Comments of the Public Staff

2020 Biennial Integrated Resource Plans of Duke Energy
Carolinas, LLC, Duke Energy Progress, LLC, and
Dominion Energy North Carolina

2020 REPS Compliance Plans of Duke Energy
Carolinas, LLC, Duke Energy Progress, LLC, and
Dominion Energy North Carolina

Docket No. E-100, Sub 165

Figure 2: Impact Of Sensitivity Analyses on the Reserve Margins

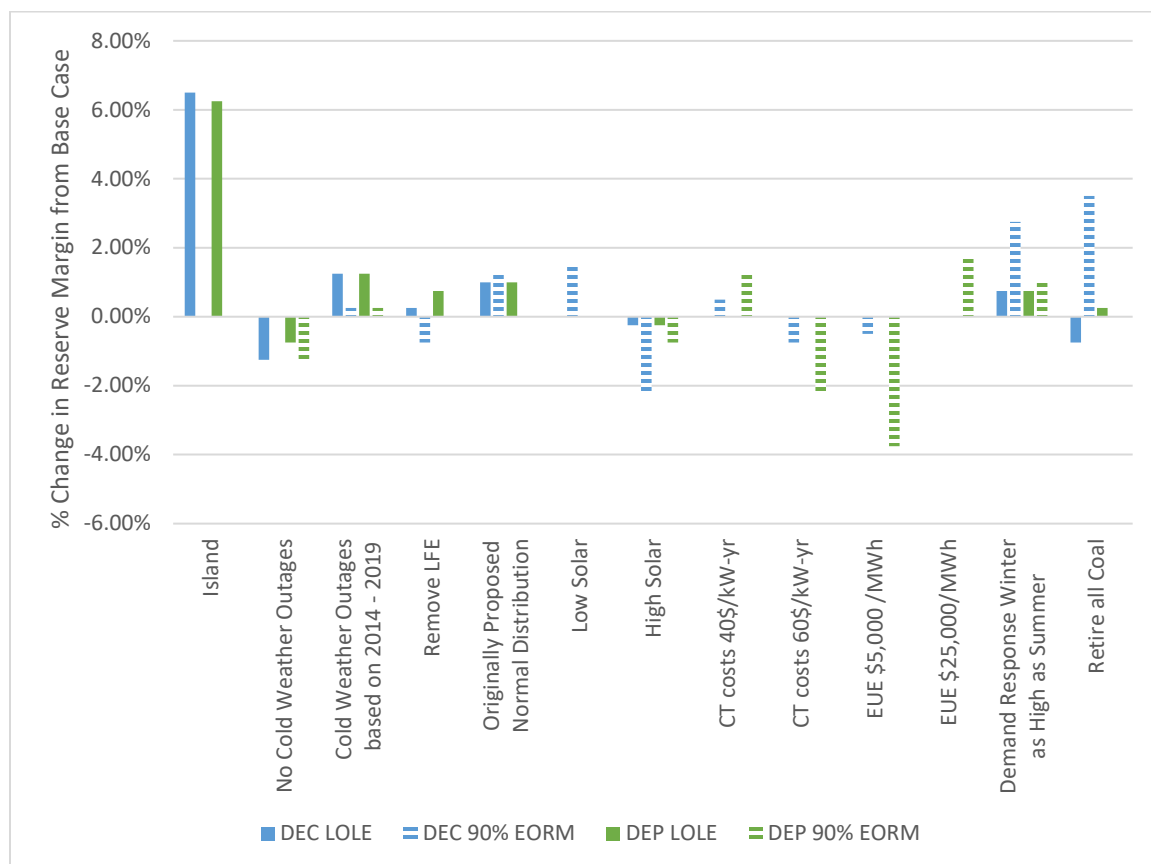
As the figure below demonstrates, the island sensitivity has the greatest impact on the reserve margin – treating DEC and DEP as wholly isolated utilities requires a significantly higher reserve margin than when they can rely on their neighbors. Under the LOLE reserve margin, the Public Staff notes that each individual change has a relatively minor impact – for example, even if all cold weather outages are removed, DEC and DEP would see a decrease of 1.25% and 0.75% in their required reserve margins, respectively. However, as the Public Staff noted in the Joint Report of the Public Staff, DEC, and DEP in the 2017 IRP

proceeding (Reserve Margin Joint Report),⁷³ the cumulative effect of several of these sensitivities can result in a significant change to the reserve margin.⁷⁴

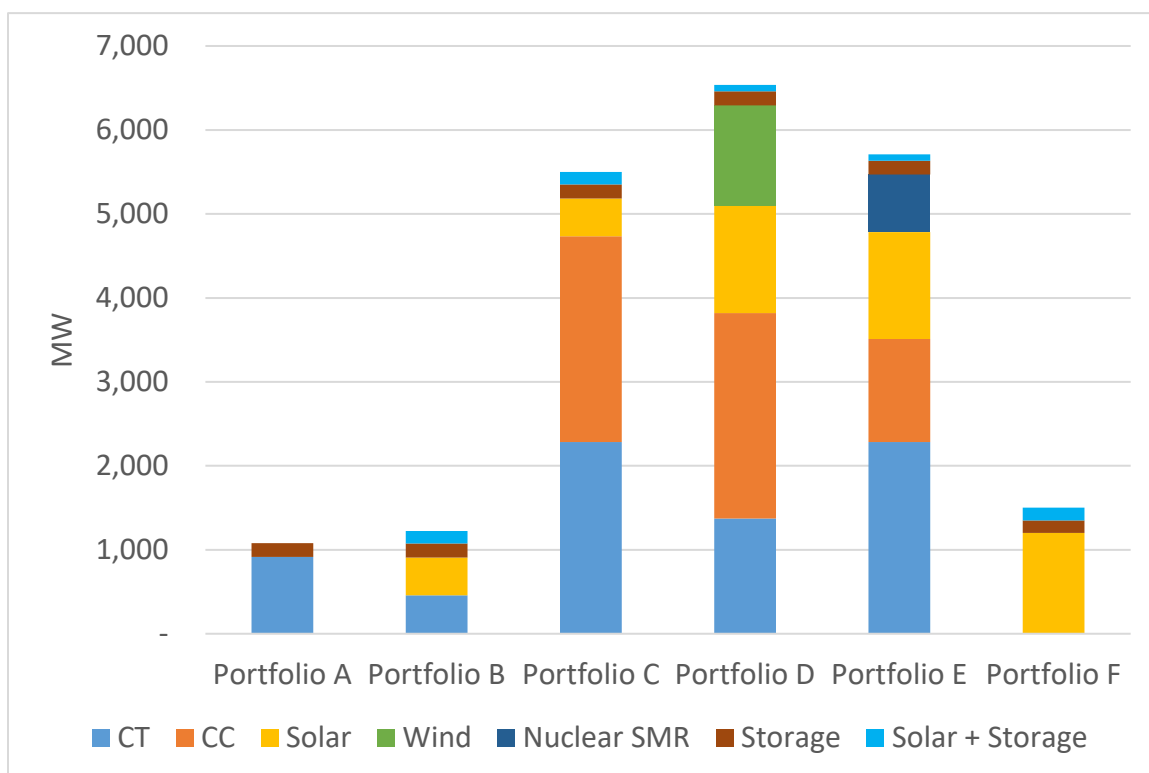
Table 19 shows that the new generation forecasted in Portfolio C, Portfolio D, and Portfolio E greatly outweighs the new generation in Portfolio A, Portfolio B, and Portfolio F. Portfolio C, Portfolio D, and Portfolio E all use the earliest practicable coal retirements, so new natural gas CCs are built, as well as new natural gas CTs. In all of the portfolios, except for Portfolio B and Portfolio F, more natural gas generation is planned in the next ten years than new renewable generation (storage is excluded from the calculation):

Figure 15: Dominion Cumulative New Builds, 2021-2030

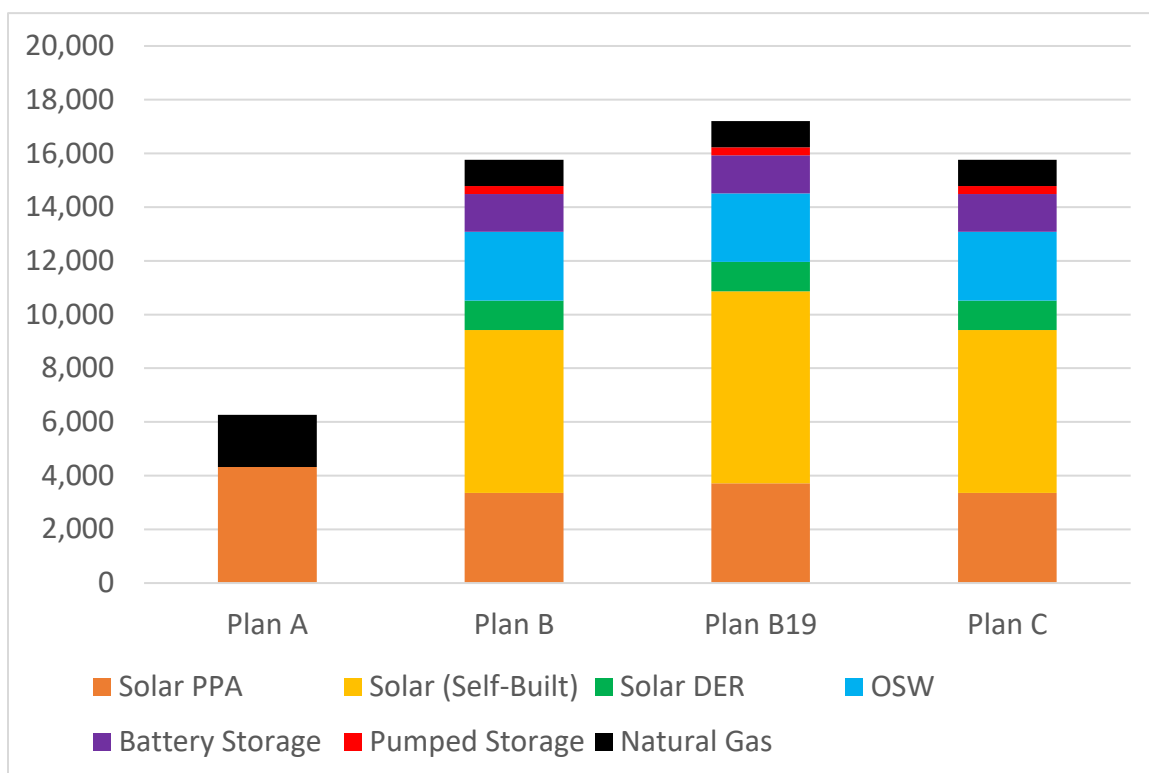
Figure 15 shows that Plan A relies on Dominion's existing generation profile and new natural gas generation for the next ten years. Plan B, Plan C, and Plan D requires large investment in renewable resources to meet the requirements of VA law.

Figure 16: DEP New Transmission Network Upgrade Capital Costs

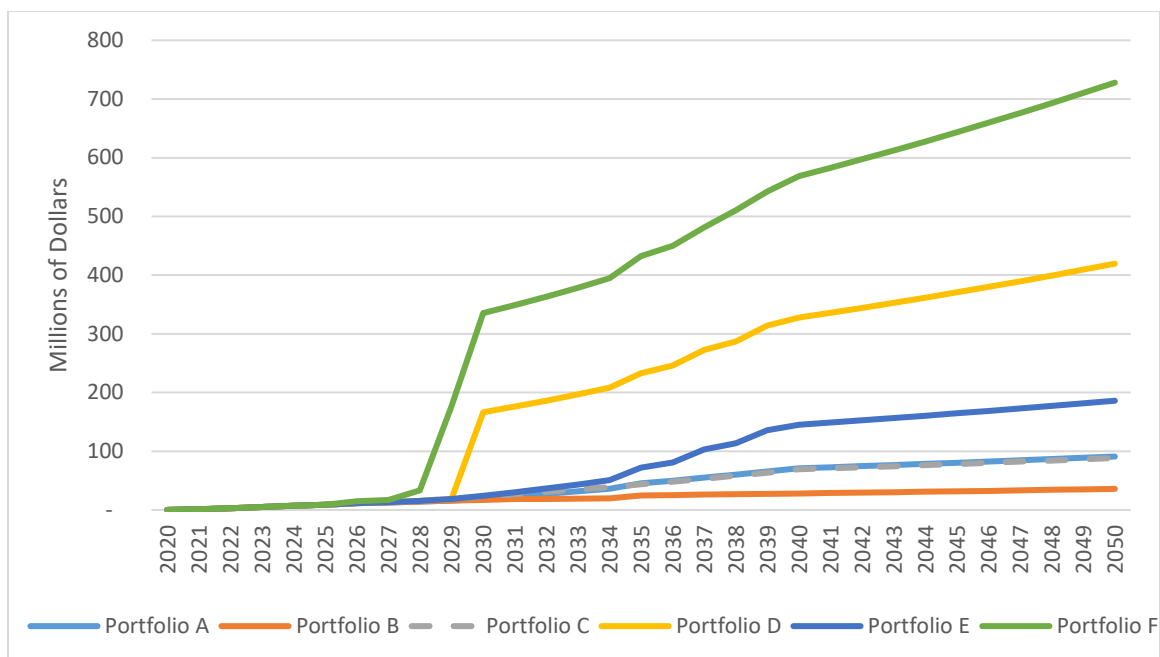
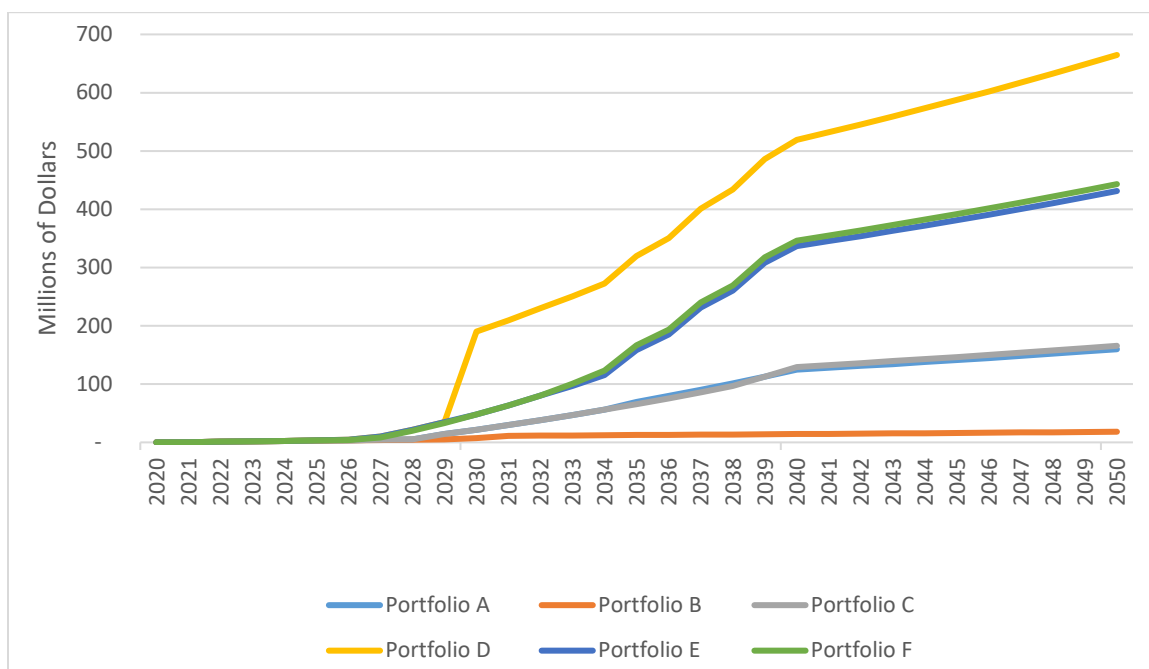
For both DEP and DEC, there is no significant difference in transmission upgrade costs among the portfolios in the short term (2020 through 2028).

However, beginning in 2029, new transmission upgrade costs relative to new generation cost are higher in the more carbon restrictive portfolios, as shown in the following graphs.¹²⁷ This increase is generally indicative of transmission network upgrade costs associated with renewable resources, which see significant growth in later planning years in most portfolios.

Figure 18: DEP New Transmission Costs as Percent of New Generation Capacity Costs

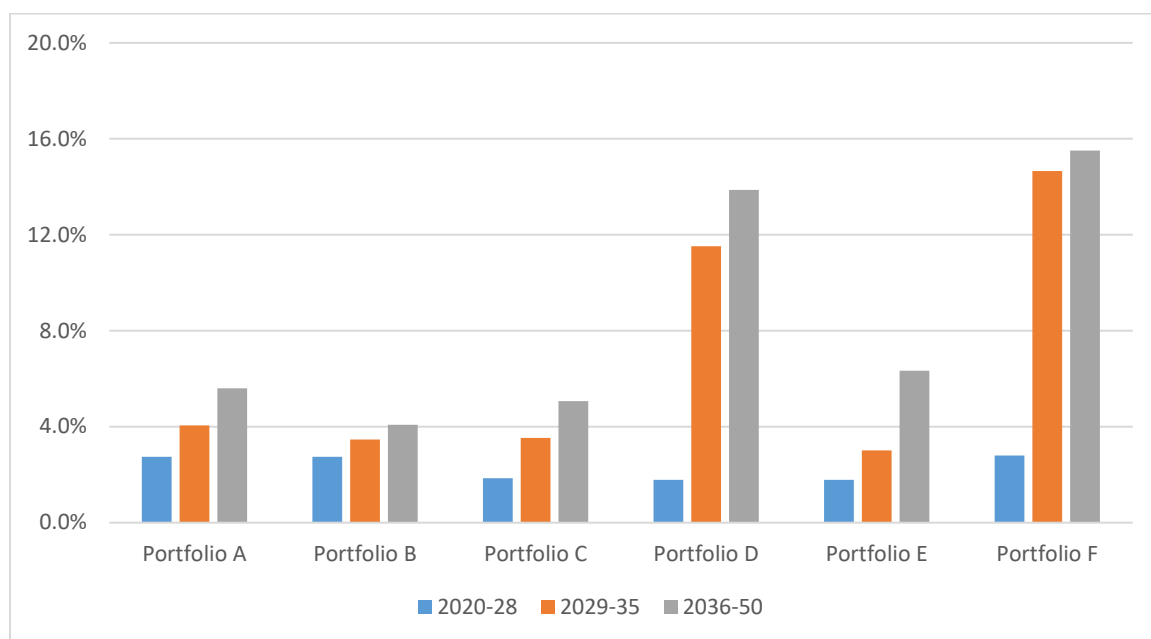
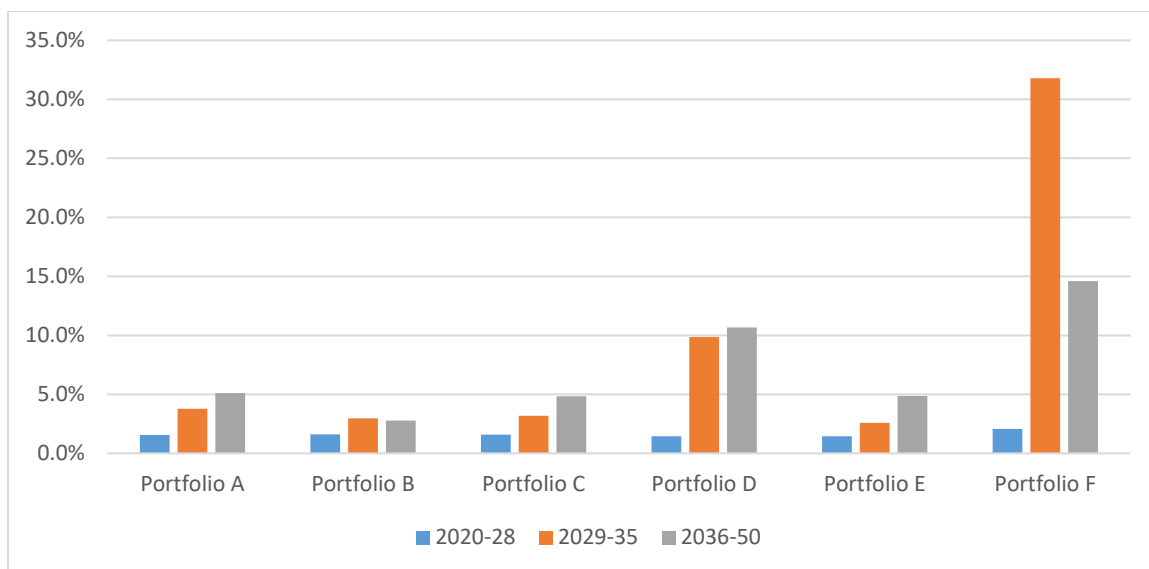
Figure 18 and Figure 19 show that for both DEP and DEC, new transmission as a percent of new generation in 2036-50 exceeds the 2020-28 period. This holds true for the 2029-2035 period with the exception of DEC Portfolios A and F (Base No CO₂ and No New Gas Generation). This is likely related to the significant investments in wind capacity in 2028 and beyond as described in the Planned Generation section of these comments.

Figure 23: Comparison of new capacity added in Duke's combined Portfolios A and B.

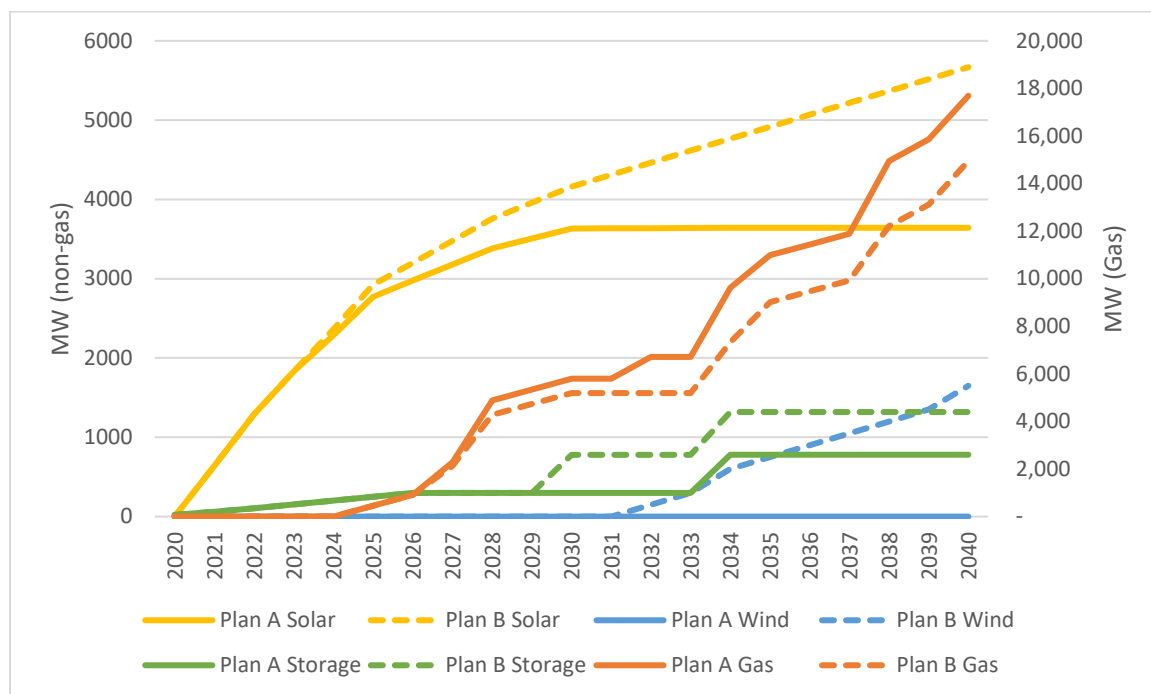
However, this analysis is complicated by other factors – namely, that whichever Portfolio (A or B) the Commission accepts for planning purposes in this proceeding is not fixed for the next 30 years. The Utilities file new IRPs every two years with updates in the intervening years; thus, the Utilities have ample opportunities to modify their plan as the uncertainty surrounding carbon legislation is resolved. Portfolios A and B are largely the same through approximately 2030, as shown in Figure 23 below. By 2030, Portfolio B has replaced approximately 600 MW of natural gas with 525 MW of solar and 480 MW of energy storage of various durations. Since Portfolios A and B are largely similar prior to 2030, Duke's short-

term action plan does not need to be changed significantly based on the selection of either portfolio.

Thus, in recommending to the Commission which Duke portfolio should be accepted for planning purposes, the Public Staff must consider the portfolio estimated costs, the uncertainty of carbon legislation, the incremental costs of the base case Portfolios A and B in various carbon legislation scenarios, and the ability of Duke to adjust course over the next ten years as the uncertainty around carbon legislation is resolved.
